**REVIEW OF EFFECTS OF SUPERCOMPACTED WASTE
AND HETEROGENEOUS WASTE EMPLACEMENT
ON WIPP REPOSITORY PERFORMANCE**

FINAL REPORT

Trinity Engineering Associates
8832 Falmouth Drive
Cincinnati, Ohio 45231-5011

U.S. Environmental Protection Agency
Office of Radiation and Indoor Air
Washington, DC 20460

Figure 5-1. Minimum mass of MgO required per waste package.

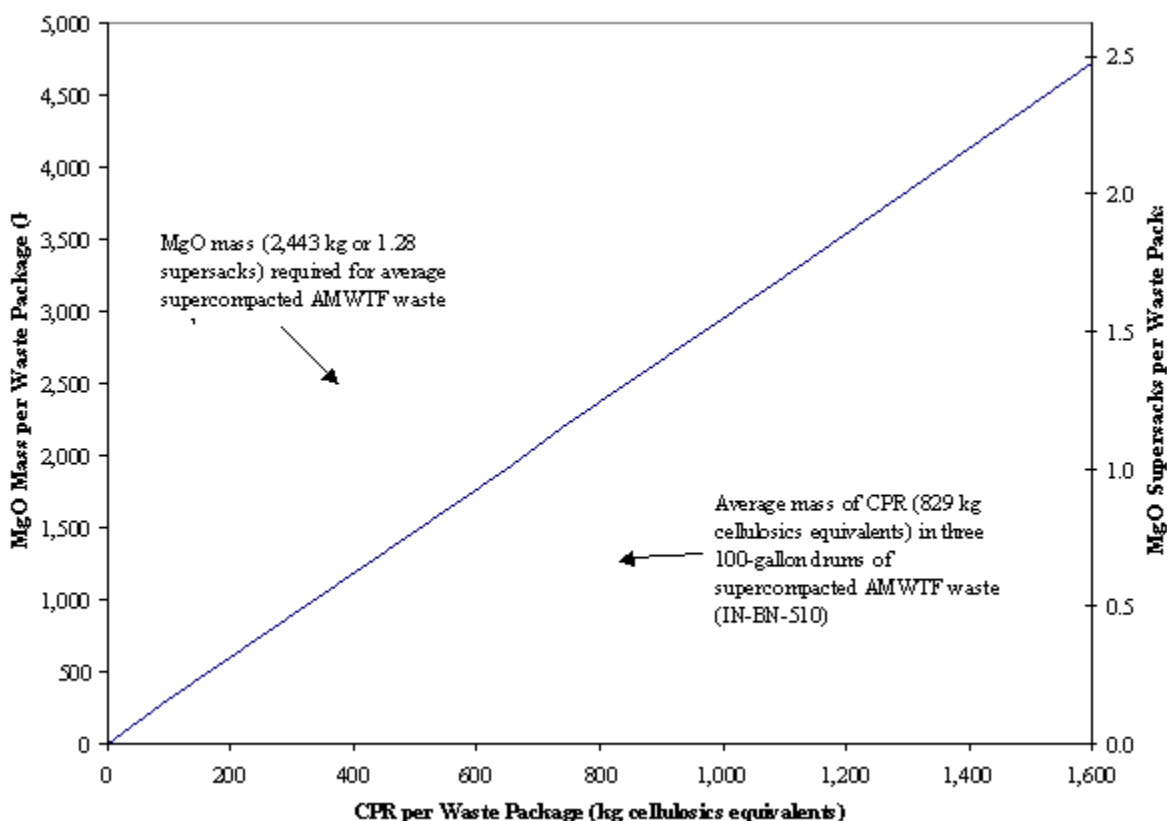
More MgO must be added to the repository than illustrated in Figure 5-1 to allow for the MgO dissolved in brine that may be released from the repository. Such releases can occur through anhydrite interbeds or intrusion boreholes and the MgO removed from the repository would not be available to react with CO₂. The volume of brine that could leave the repository can conservatively be set equal to the volume of brine that could enter the repository. The amount of MgO that would be dissolved in the maximum volume of brine that could enter the repository is 4.81×10^5 kg (Snider, 2003a and 2003b). This would require the placement of an additional 253 MgO supersacks in the repository.
